HORIZON®. HRZ-D MANUAL
ADDENDUM
June 1980

ADDENDUM to: HRZ-D MANUAL, REVISION_1

JUNE 4, 1980

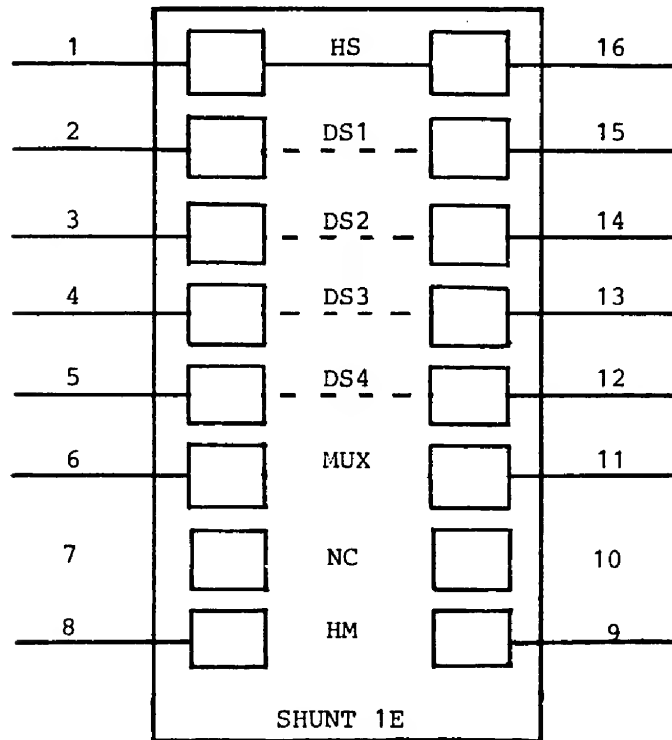
- 2) The HRZ-D Manual is the proper documentation for North Star's quad capacity HORIZON, HRZ-Q. Quad capacity HORIZON systems are essentially the same as double density HORIZON systems (HRZ-D). They differ from double density systems in that the one or two drives included with quad capacity system are quad capacity drives and not double density drives, as included in a double density system. Furthermore, the blank diskette included with a quad capacity HORIZON system is a double-sided diskette, not a single-sided diskette as included with double density HORIZON systems. In all other ways, the quad capacity HORIZON systems are the same as the current double density HORIZONS.
- 3) The capacitors C5, C6, C8, and C9 will no longer be installed in the HORIZON motherboard. Make the following changes to the HRZ-D Manual, Rev. 1:

PARTS LIST CHANGES

- A. On page 12, in the section titled DISK SUB-SYSTEM (MDS-H) PARTS LIST, delete two .047uf ceramic capacitors from the parts list.
- B. On Page 13, in the section titled SECOND DISK DRIVE (HRZ-DRV) PARTS LIST, delete two .047uf ceramic disc capacitors from the parts list.

INSTRUCTION CHANGES

- A. On page 37, delete instruction D1 in the section titled DISK DRIVE #1 POWER REGULATION ASSEMBLY.
 - B. On page 38, delete instruction E1 in the section titled DISK DRIVE #2 POWER REGULATION AND CABLE ASSEMBLY.

HORIZON CHASSIS/MOTHERBOARD MB-4

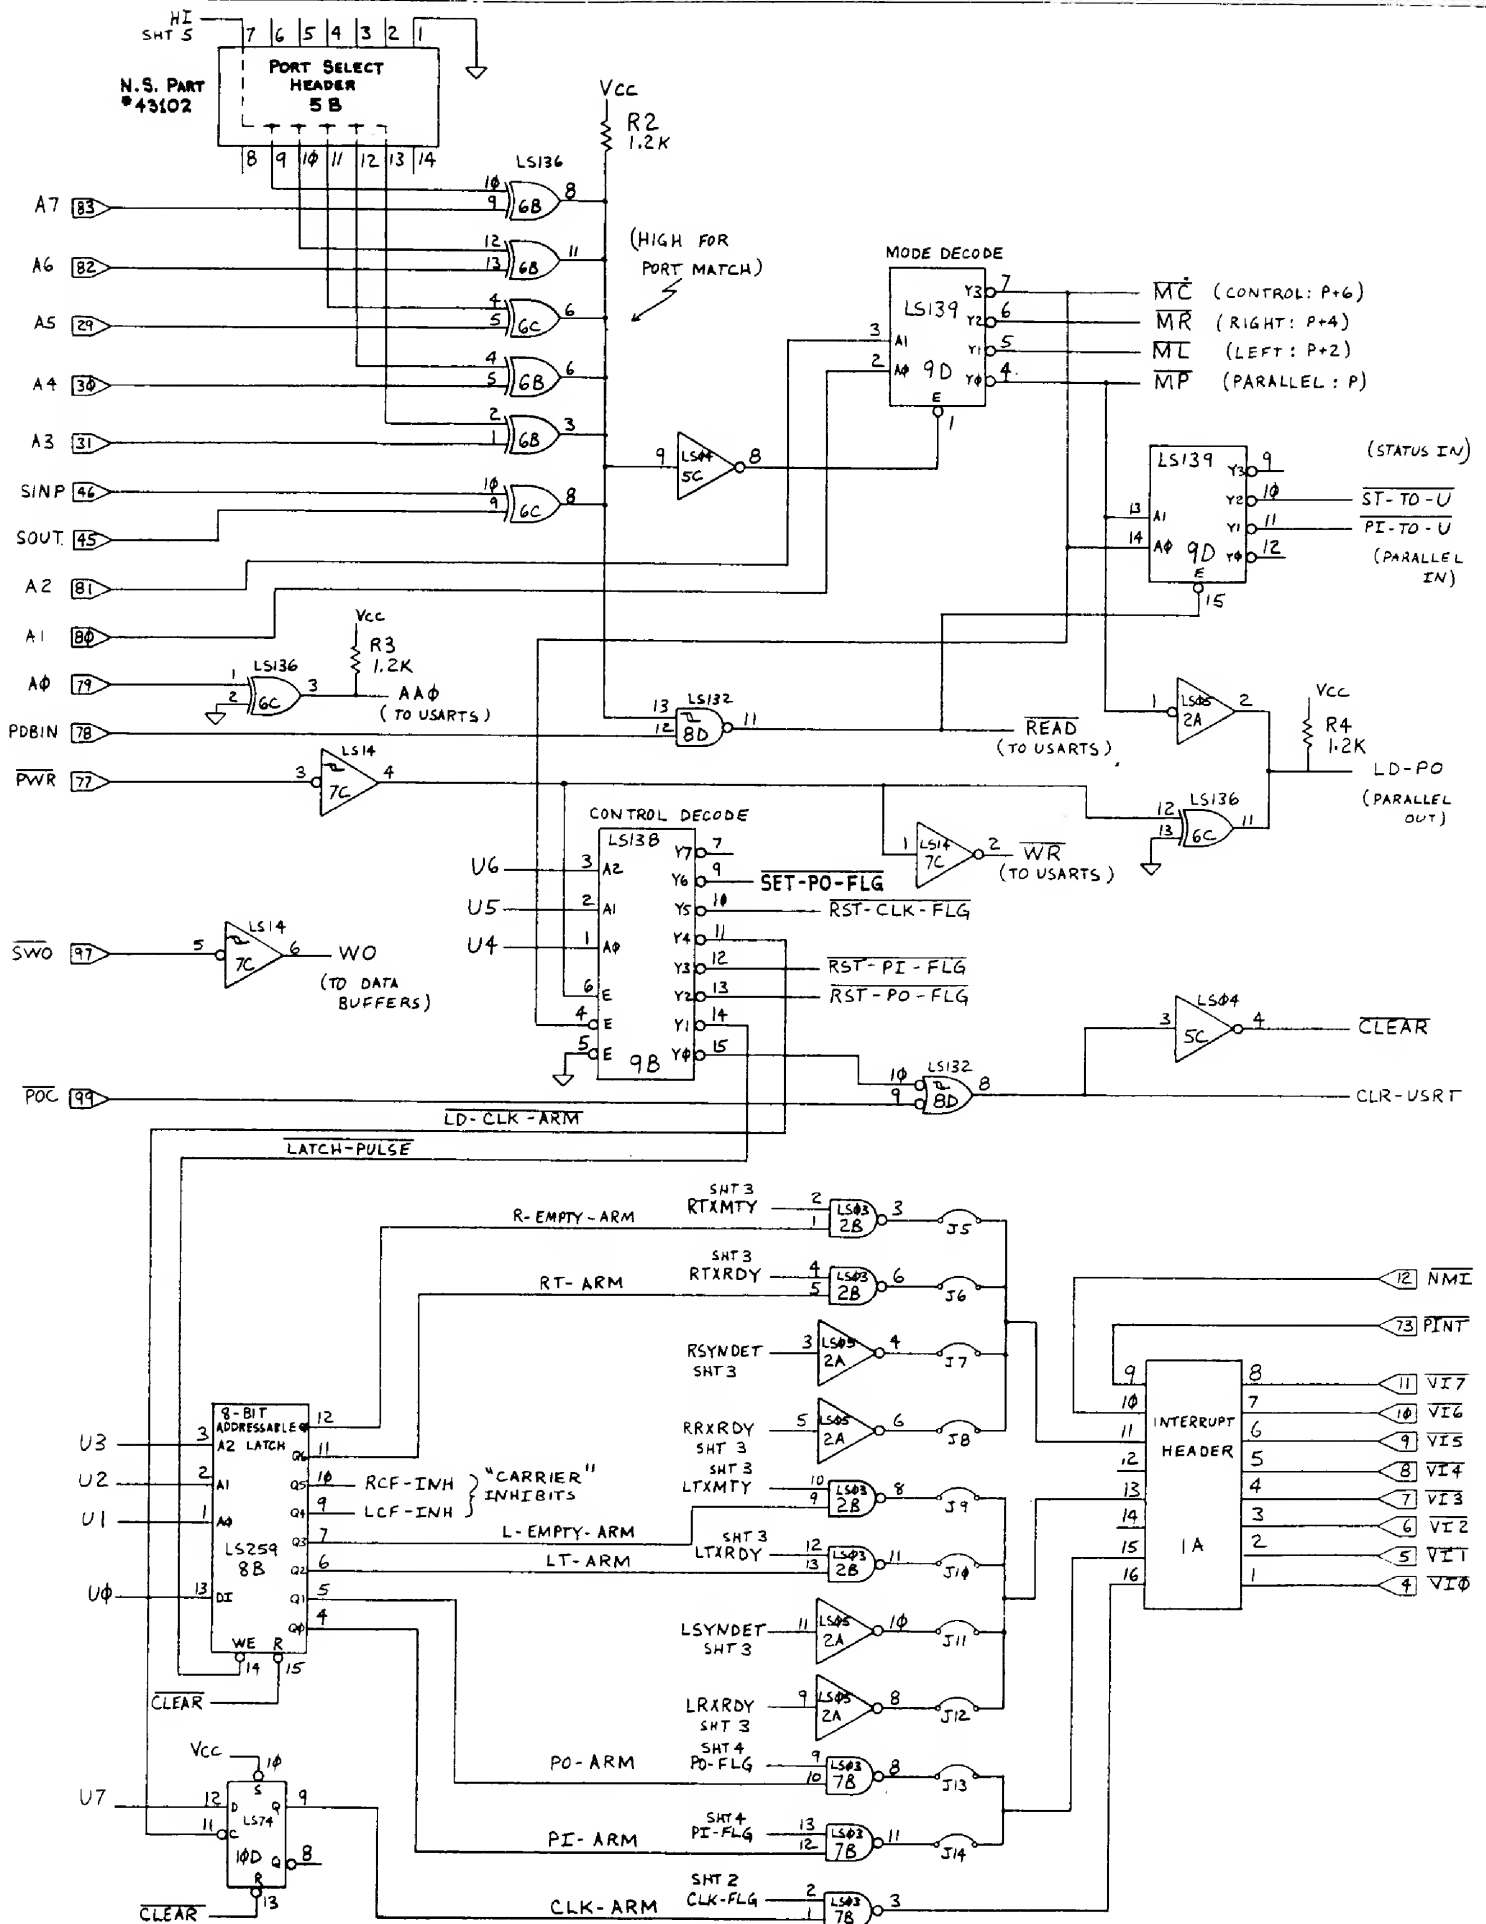
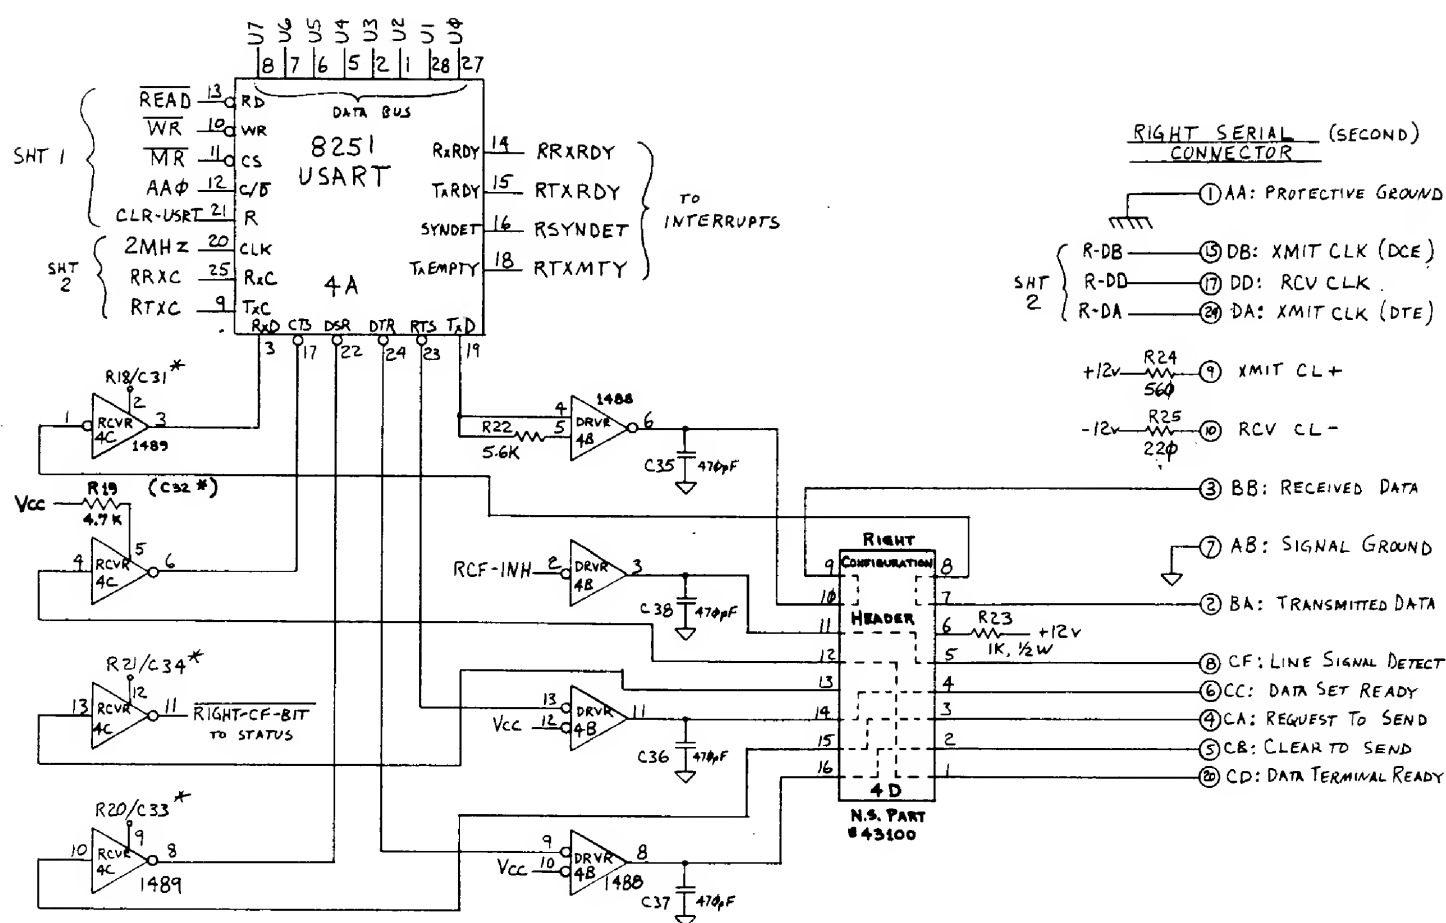
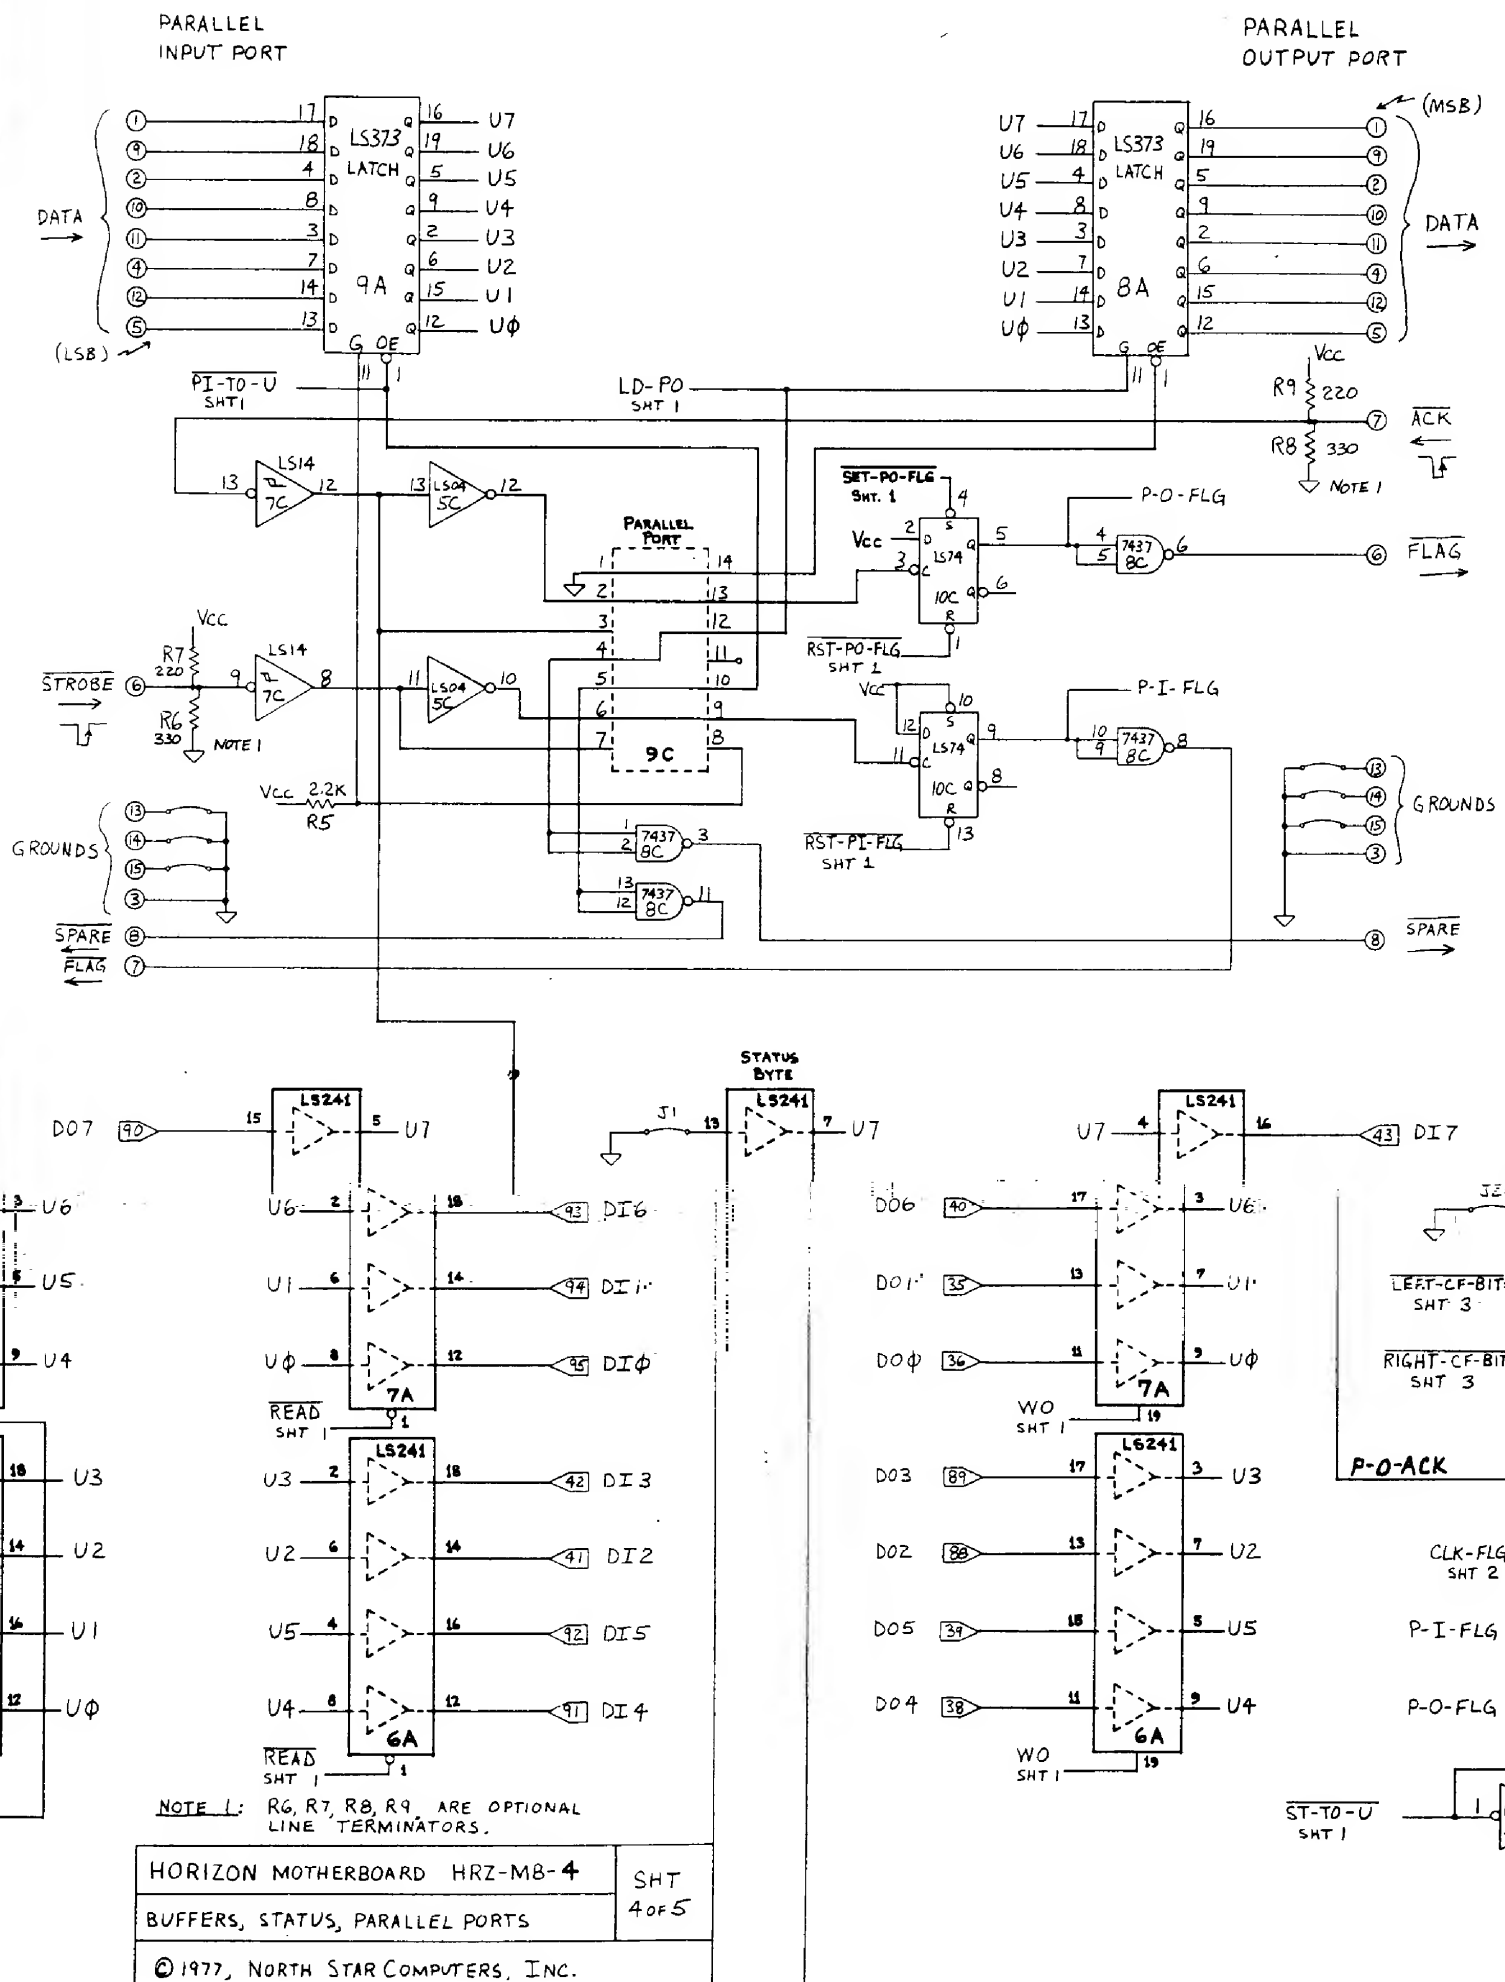
11) For all HORIZON Computer Systems containing motherboards marked "HRZ-MB-4", the following five pages of schematic drawings supersede pages 88, 89, 91, and 92 of the HORIZON Manual.
